CITY of NOVI CITY COUNCIL

Agenda Item H
June 8, 2015

SUBJECT: Approval of a request from Diversified Members Credit Union for a variance from Section 11-94(b)(3)(1) of the Design and Construction Standards, which requires storm sewers receiving surface runoff to be a minimum diameter of 12 inches, to allow the applicant to install a 6-inch diameter storm sewer in order to make a connection for the outlet and to avoid conflicts with AT&T conduits, for the Diversified Members Credit Union project (parcel 50-22-23-176-033).

**RE: Minimum Pipe Size Design Variance – Updated Plans
Detroit Metropolitan Credit Union
Proposed Bank with Drive-Thru Facilities
Parcel ID# 22-23-176-033
City of Novi, Oakland County, Michigan
JSP 12-0069**

UTILITIES PLAN

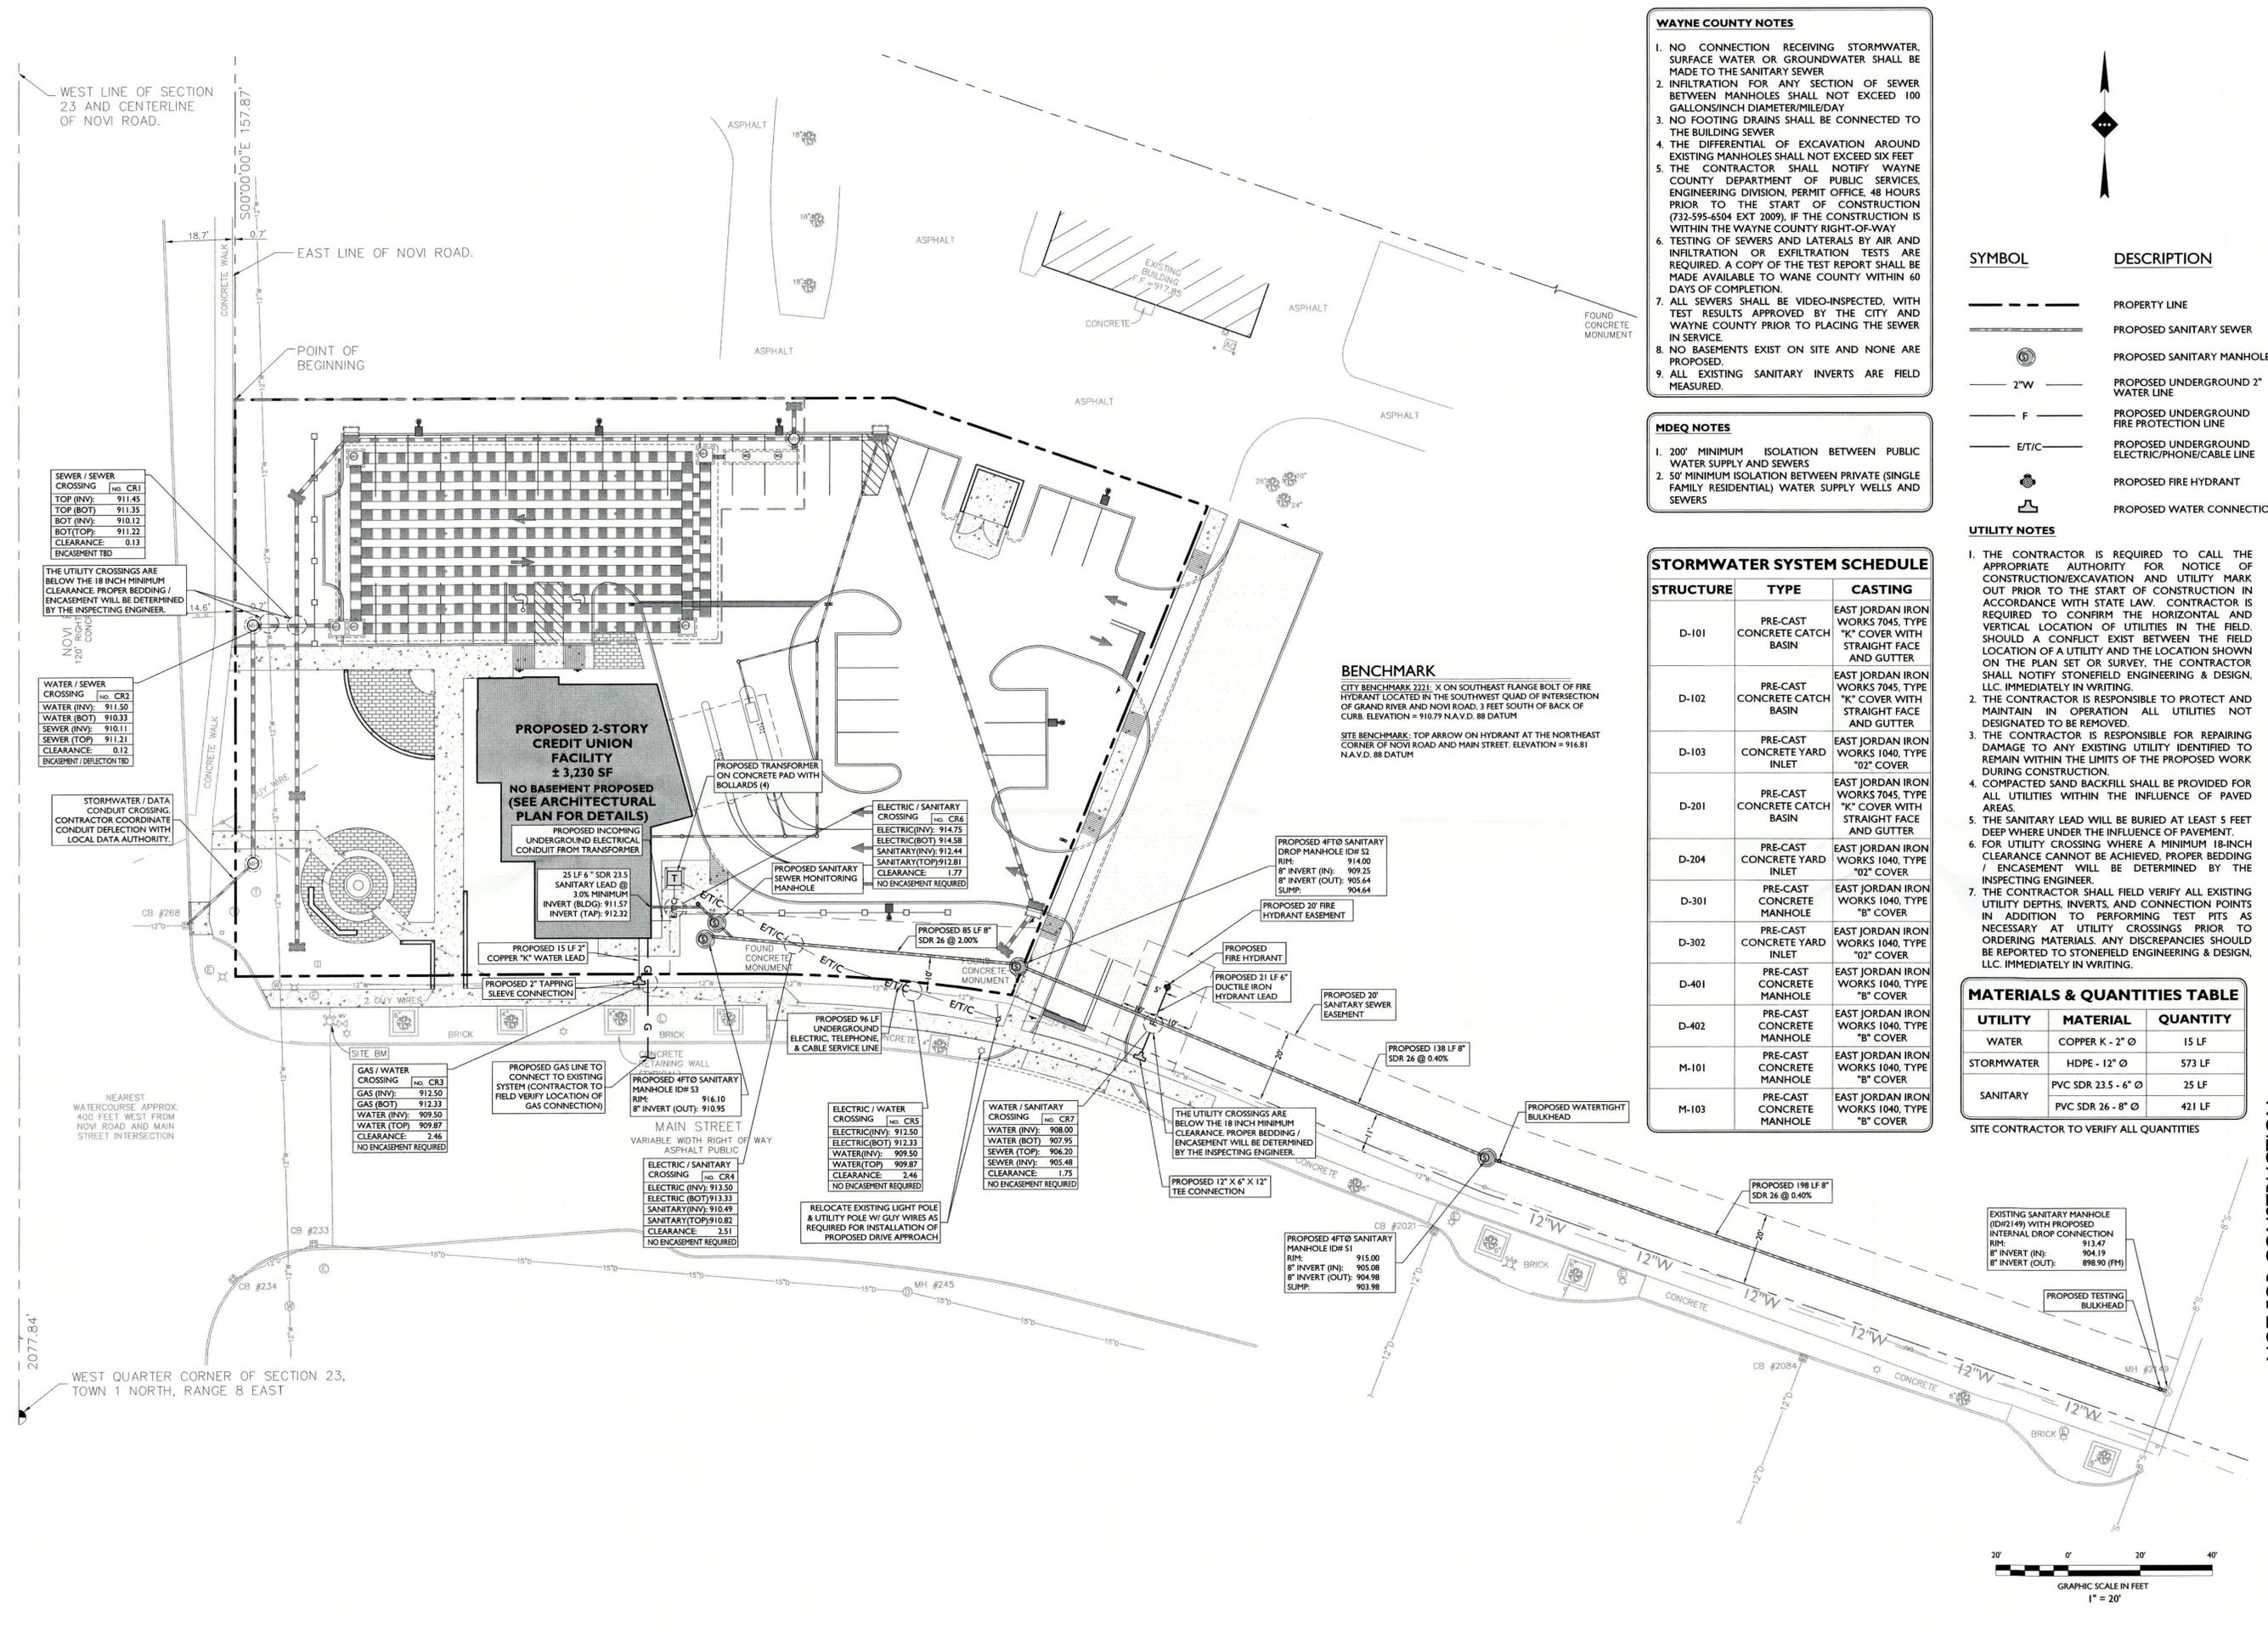
Variance Request Install a 6-inch HDPE pipe from the on-site manhole to the catch basin in Novi Road.

During initial site preparation, the contractor performed several exploratory test pits to confirm the feasibility of the proposed utility crossings. At one crossing (from structure D-401 to the existing catch basin in Novi Road) it was discovered that an AT&T conduit bank (eight conduit lines) exists along the length of Novi Road that conflict with the location of the stormwater pipe. After holding discussions with AT&T it was determined that if the pipes were reduced in size but doubled up (i.e. two 6-inch pipes) the conduits can be deflected above and below the pipes with minimal issues.

STORMWATER / DATA CONDUIT CROSSING. CONTRACTOR COORDINATE CONDUIT DEFLECTION WITH LOCAL DATA AUTHORITY.

The drawings have been updated per the Department's comments to reduce the amount of 6-inch piping proposed to only what is required for the conduit crossing. Please contact our office if you have any questions or comments regarding this submission.
